Our ref
PLAN-035278

Date
29/10/2020

Proposal: Residential Mews consisting of 6 No dwellings. This application may affect the Norton Lane, Norton Conservation Area, may affect the setting of a listed building, is a Departure from the Development Plan & is in CIL Zone 3 & is CIL Liable.

Site: AL/70/20/PL: - West Barn, Old Dairy Lane, Norton, PO20 3AF.

Southern Water MapGuide Browser

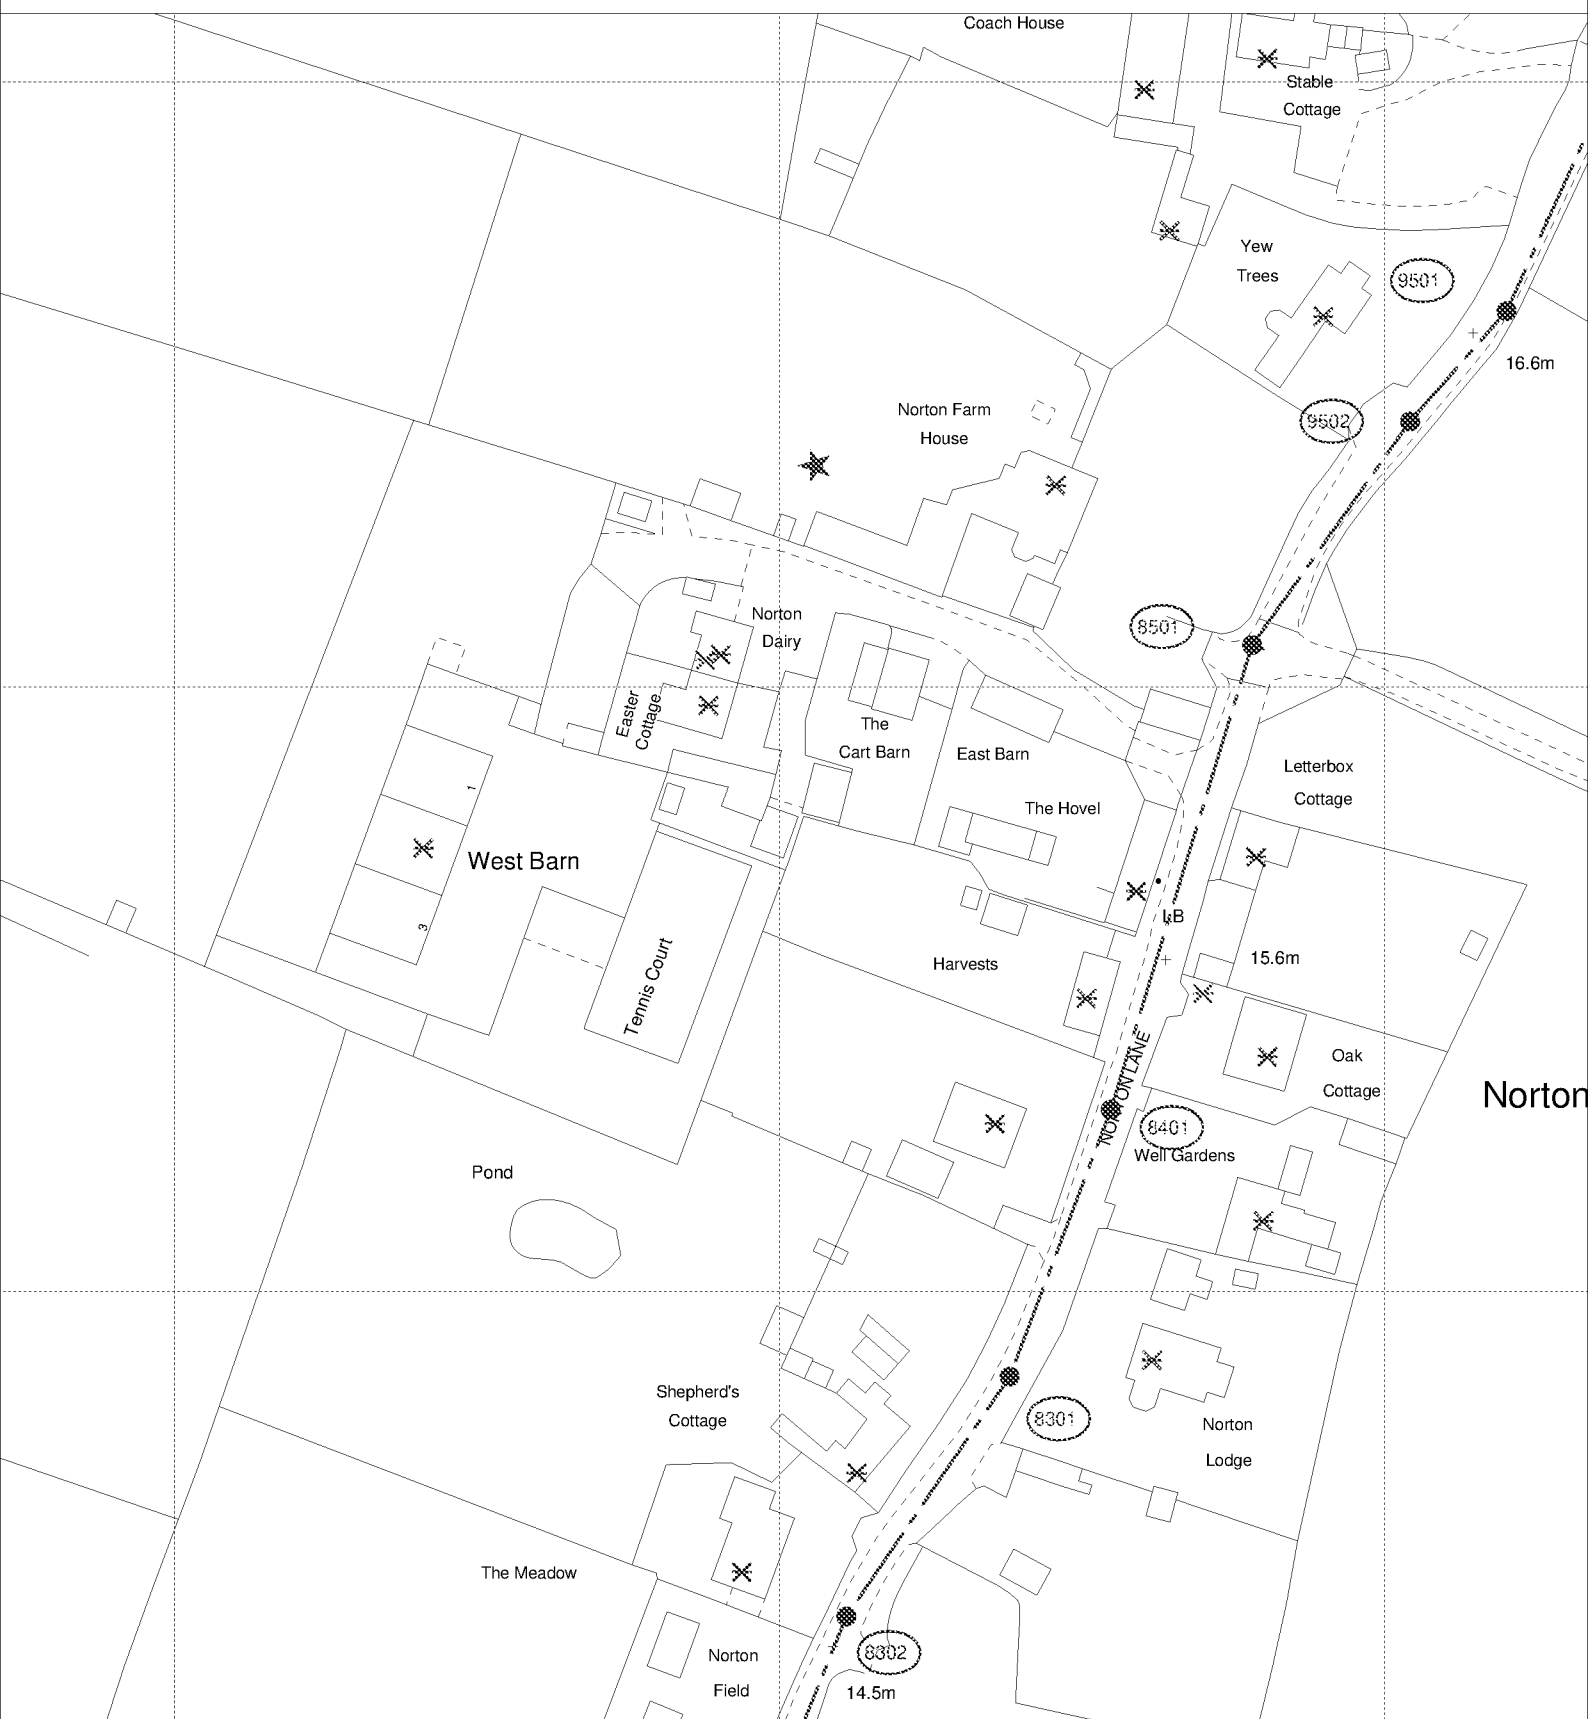
It is possible that a sewer now deemed to be public could be crossing the development site. Therefore, should any sewer be found during construction works, an investigation of the sewer will be required to ascertain its ownership before any further works commence on site.
